Product Change Notice (PCN)

PCN Number: **PCN-0451100R-02**

Product(s) Affected: SJD1-3201-54

PREVIOUS CUI DEVICES DETAIL / IMAGE	NEW CUI DEVICES DETAIL / IMAGE

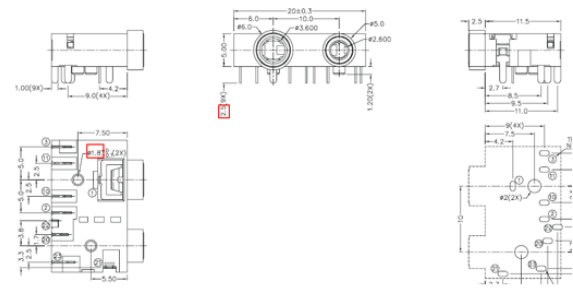
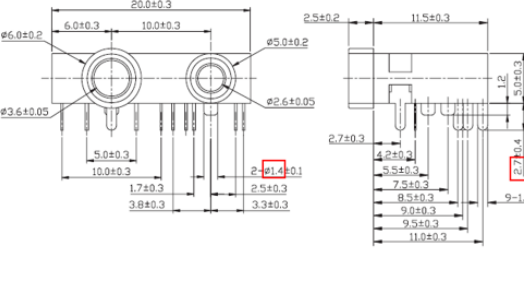
Description of Change: mechanical and material differences as shown below:

MATERIAL	PLATING	DESCRIPTION	MATERIAL	PLATING/COLOR
terminal 1	copper alloy	tin	terminal 1	copper alloy	tin
terminal 2	copper alloy	tin	terminal 2	stainless steel t=0.20	tin
terminal 3	copper alloy	tin	terminal 3	stainless steel t=0.20	tin
terminal 10	brass	tin	terminal 10	brass t=0.40	tin
terminal 11	brass	tin	terminal 11	brass t=0.40	tin
terminal 20	brass	tin	terminal 20	brass t=0.40	tin
terminal 21	copper alloy	tin	terminal 21	phosphor bronze t=0.30	tin
terminal 22	copper alloy	tin	terminal 22	stainless steel t=0.20	tin
terminal 23	copper alloy	tin	terminal 23	phosphor bronze t=0.25	tin
bushing	brass	nickel	bushing	copper alloy	nickel
plastic	PBT		housing	PAB6+GF15% (UL94HB)	black
